File No. 88-34734-CE

**PLAINTIFF'S BRIEF IN RESPONSE TO PETITION FOR DISPUTE  
RESOLUTION AND IN SUPPORT OF IMPOSITION OF STIPULATED PENALTIES**

9. I have reviewed the Evergreen System Review (ESR) report, dated May 2007, submitted to the DEQ on May 10, 2007 and the associated groundwater model developed by Fishbeck, Thompson, Carr & Huber, Inc. (FTC&H). My detailed review of the groundwater model is included in the attached Interoffice Communication dated July 13, 2007 (Exhibit 1). It is my opinion that there are three main issues with the ESR; 1) Data deficiencies that limit the proper characterization of the vertical and horizontal extent of 1,4-Dioxane contamination and correct assessment of groundwater flow and contaminant migration directions, 2) The ESR relies heavily on simulations made with a groundwater flow model that is not calibrated, and 3) The lack of a monitoring network that is installed for the sole purpose of assessing the performance of the Evergreen System.

Figure 1 – Location of downgradient constant-head boundary.

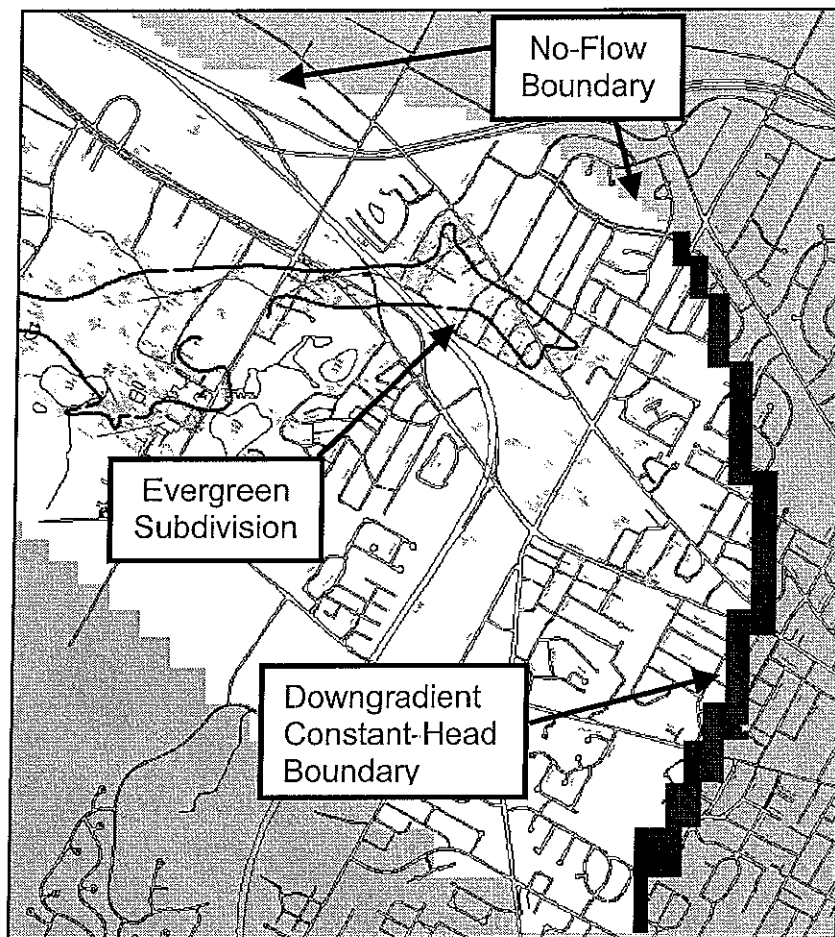
The placement of the no-flow boundary and the downgradient constant-head boundary relatively close to the Evergreen System, besides determining groundwater flow direction in the model, results in a distorted cone of depression that will distort the simulated capture extent. Figure 7 shows the simulated drawdown for model layer two (Unit D aquifer) assuming a pumping rate of 202 gpm from the Evergreen System wells. The combined impact that these boundaries, the inferred zone of low hydraulic conductivity to the south of LB-1 and LB-3, and the lack of connection between the Unit D and Unit E aquifers (model layer three was assumed to be continuous throughout this area) have had on the simulated extent of capture should have been assessed.

It is our opinion that the no-flow boundary is not correct, nor is it supported by any field data. The impact of placing the no-flow boundary in this area on simulated flow directions and capture extent must be verified and assessed. In addition, the current constant-head value assignments in this downgradient boundary may be impacted by the elimination of pumping from the Montgomery Street well. Any future model simulations will have to assess the appropriateness of this constant head boundary or its impact on simulation results.

Figure 6 – Direction of Regional Groundwater Flow

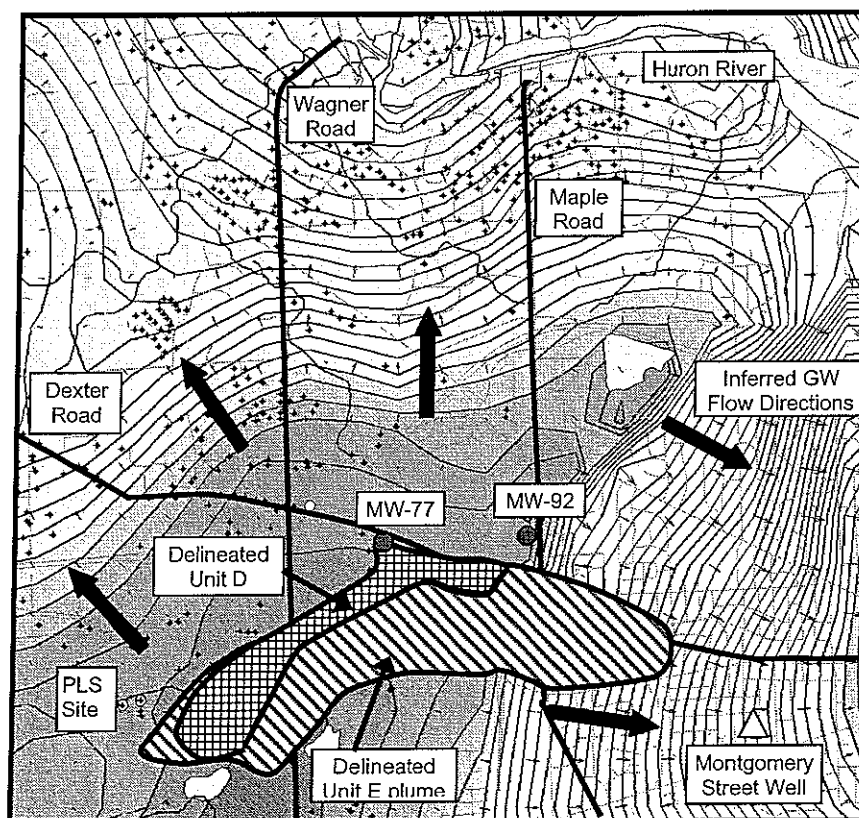
North of Dexter Road, the inferred directions of groundwater flow (see Figure 6) suggests that there may be the possibility of some contaminant migration to the north. However, the verification of groundwater flow and contaminant migration directions north of Dexter Road is incomplete, primarily because so little good-quality data (obtained through vertical aquifer sampling) have been collected in this area. In the model, the placement of the no-flow boundary to the north prevents the model from simulating a northward groundwater flow direction. As a result, the simulated groundwater flow direction near Dexter Road is due east, rather than to the north. This is an artifact of the manner in which the model is constructed that has not been verified by the collection of field data. Additional good-quality data (groundwater levels or chemical analyses) are needed north of Dexter Road to verify whether the west-to-east simulated flow directions or the regional groundwater flow directions to the north that are shown in Figure 6 are correct.

Figure 8 – Reverse Particle-Tracking in Model Layer 2, Evergreen System pumping 202 gpm.

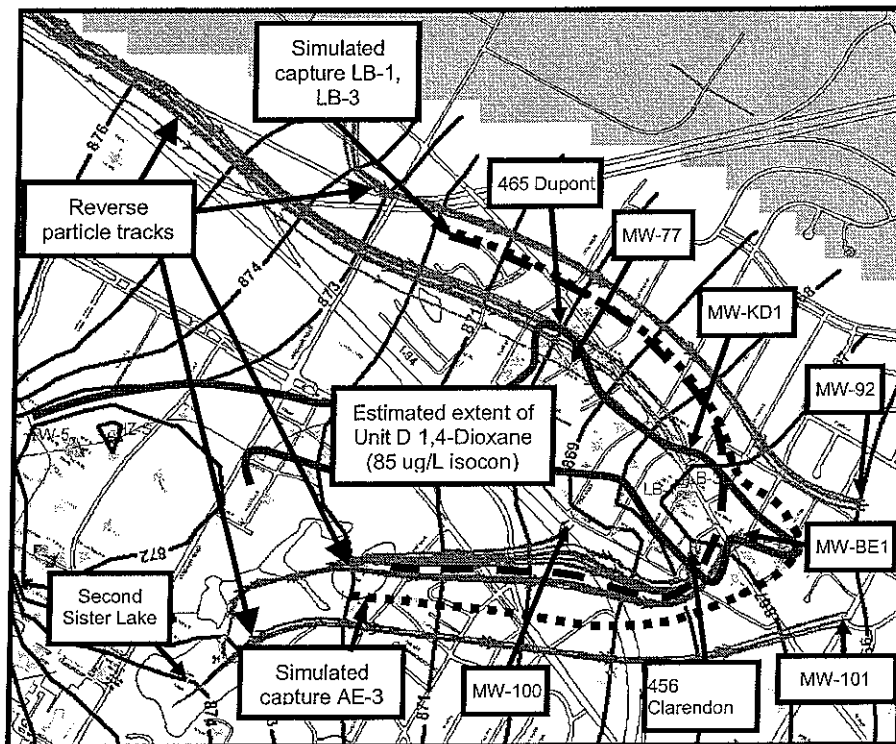
A reverse particle-tracking analysis was performed using the 2007 Model by placing particles around several monitoring wells at which the concentrations of 1,4-Dioxane have been increasing or are near the edge of the simulated capture extent. The objective is to assess the possible origin of the contaminants that have been detected in these Unit D aquifer monitoring wells. Figure 8 shows the reverse particle tracking analysis with the Evergreen System wells pumping at a combined rate of 202 gpm (LB-1 = 90 gpm, LB-3 = 80 gpm, and AE-3 = 32 gpm). Particles were released around wells MW-77, MW-92, MW-100, MW-101, MW-KD1, MW-BE1, 456 Clarendon, and 465 Dupont. These simulations, if accurate, show that contaminants and groundwater found in the wells at 465 Dupont, MW-77, MW-KD1 and MW-92 would have migrated entirely within the Unit D aquifer from the west-northwest, from an area that is north and west of the delineated extent of the Unit D 1,4-Dioxane contamination (north of the intersection of Wagner Road and M-14). The reverse particle tracking analysis also shows that the contaminants and groundwater found at MW-100, 456 Clarendon, MW-BE1, would have migrated entirely within the Unit D aquifer from an area southwest of I-94 and MW-101. This area is south of the delineated southern extent of the Unit D aquifer plume.

The simulated capture extent and delineated extent of Unit D 1,4-Dioxane contamination are also shown on Figure 8. Wells MW-77, MW-100, MW-KD1, MW-BE1, 456 Clarendon, and 465 Dupont are all located within the simulated extent of capture. Only wells MW-92 and MW-101 are found outside the simulated capture extent of the Evergreen System. It's important to point out that the particles representing contaminant and groundwater flow to these wells do not enter the Unit E aquifer at upgradient locations, indicating no upwelling of groundwater from this lower aquifer to the Unit D aquifer. The model simulations would indicate that all of this contaminated groundwater comes from the Unit D aquifer, some of it coming from areas where 1,4-Dioxane concentrations have not been detected in the Unit D aquifer or there has been no investigation of possible 1,4-Dioxane contamination.

Figure 10 – Simulated heads and capture extent for Model Layer 2 (LB-1 = 67 gpm, LB-3 = 60 gpm, and AE-3 = 32 gpm).

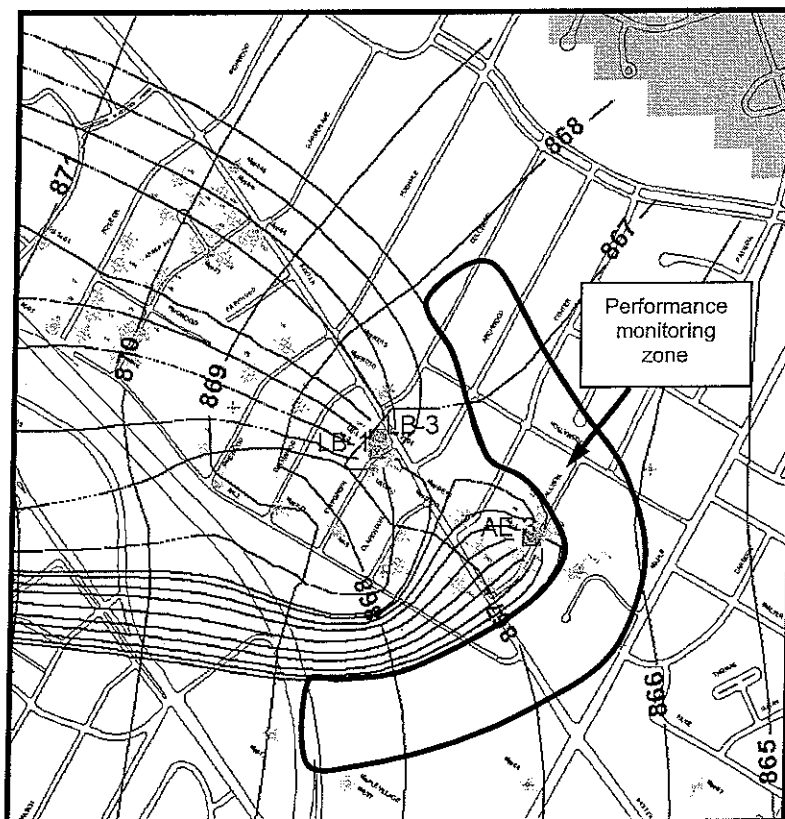
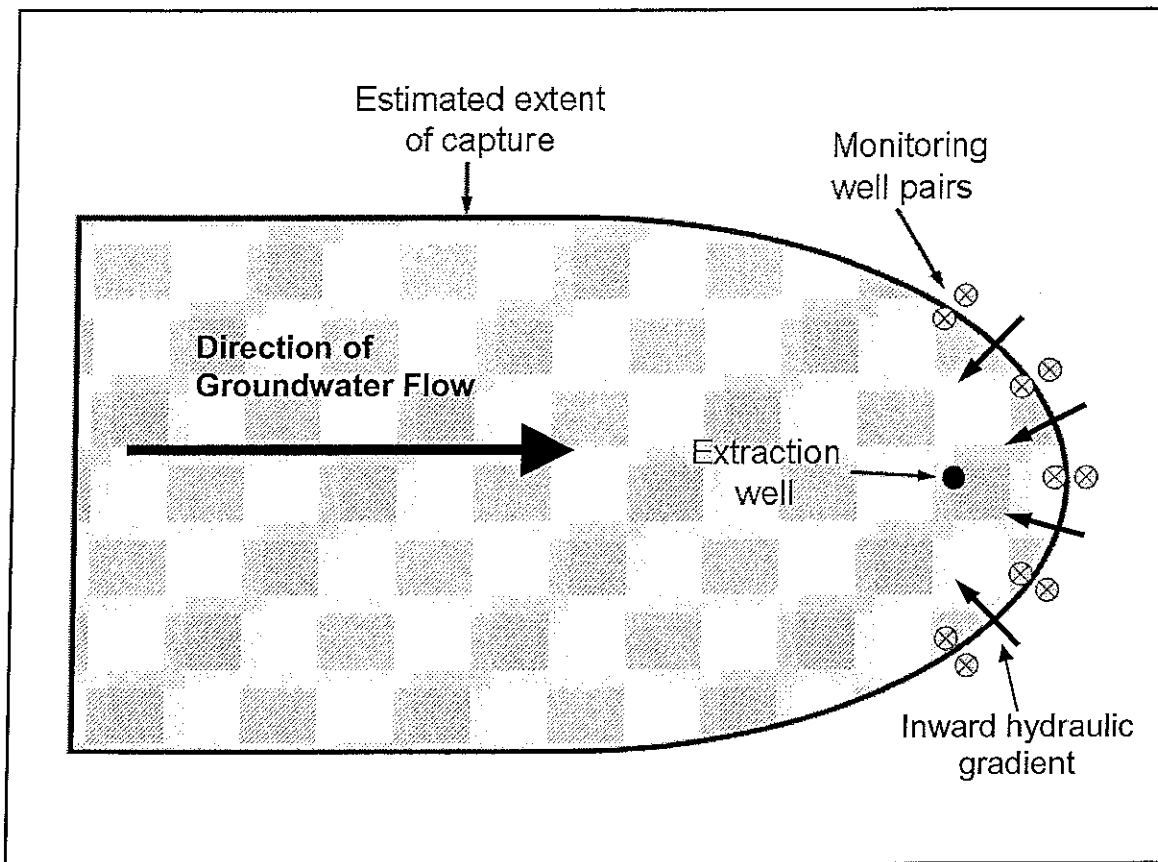
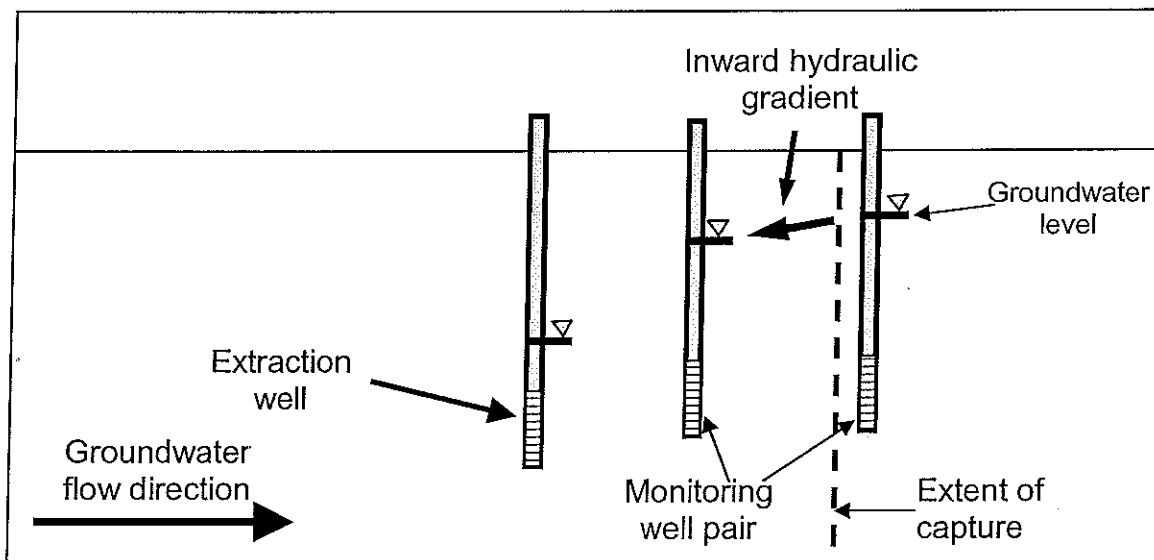
Evergreen, only monitoring wells MW-47S and MW-47D are in a location that may be appropriate. A figure showing a zone within which monitoring well pairs should be located downgradient of the Evergreen System wells is found in the attached memo (see Figure 10).

It is necessary to have data upon which to make timely decisions regarding the effectiveness of the performance of the Evergreen System or whether to adjust system pumping rates. This requires that monitoring well clusters be placed immediately beyond the estimated capture extent of the Evergreen System, not far downgradient. PLS has proposed to monitor selected unidentified monitoring wells while pumping rates in wells LB-1 and LB-3 are decreased; however, there are no existing wells that can be used to measure hydraulic gradients that would show hydraulic containment. Most available wells are not screened on the basis of VAS investigations, are not part of a monitoring well cluster, or are located too far downgradient to make a timely decision regarding the effective or optimum operation of the Evergreen System.
